Rezoning Transportation Analysis

Petition Number: 2026-020

General Location Identifier: 22120106

Date	Description
4-23-26	First Review (NK)
5-19-26	Second Review (NK)

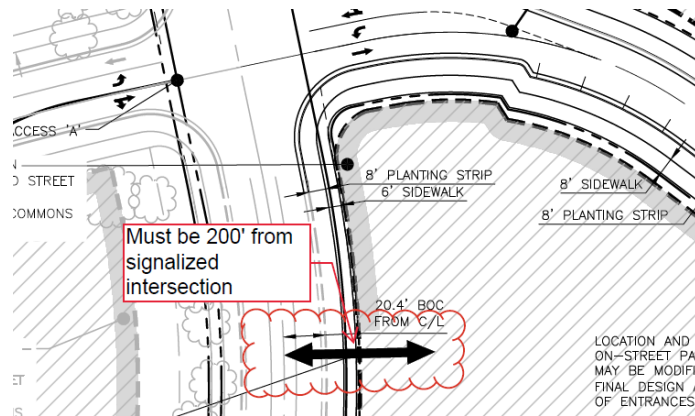
Petitioner to provide responses to the staff comments below as well as specify other changes to the site plan.

1. ~~Comprehensive Transportation Review (CTR):~~

~~A Traffic Impact Study (TIS) is not required for the complete review of this petition due to the site generating site trips under ordinance thresholds found in the Charlotte Streets manual Table 3.1 and/or not triggering any other City TIS requirements.~~

2. ~~Revise site plan and conditional note(s) to commit to placing access at least 200' from signalized intersection.~~
